Technical Bulletin

Product Line: Bambi

Models: Sacksafoam I

Subject: New Sacksafoam Controller

Figure 2- Recommended wiring

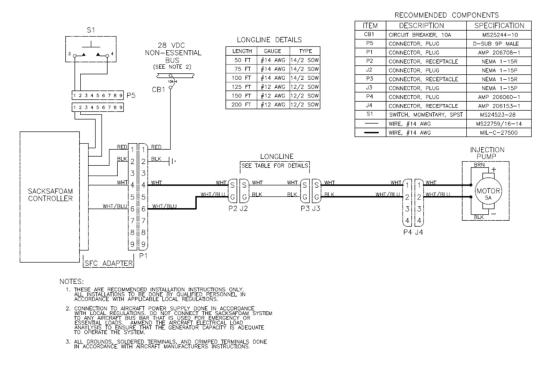
The SFC is operated with a glove compatible touch screen. The SFC includes an adapter that connects to the existing Sacksafoam wiring harness and includes a D-sub connector that can be used to connect with a remote injection switch. See Figure 2 for details.

DZUS rail adapters are available for the SFC. Please note that the product dimensions have changed and the new SFC will not fit in the same location on a DZUS rail system as the original Sacksafoam controller.
